SI B64 01 13
Heating and Air Conditioning

This Service Information bulletin supersedes SI B64 01 13 **dated February 2013.**

IHKA Operating Panel Buttons Are Peeling

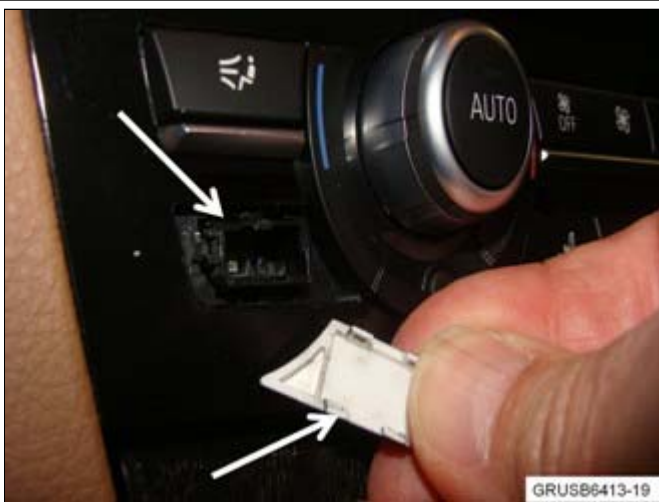
In the picture below, you can clearly see how the low fan speed button is just starting to peel. Two of the four fan blades are missing from the button symbol, and soon the entire symbol will be gone.
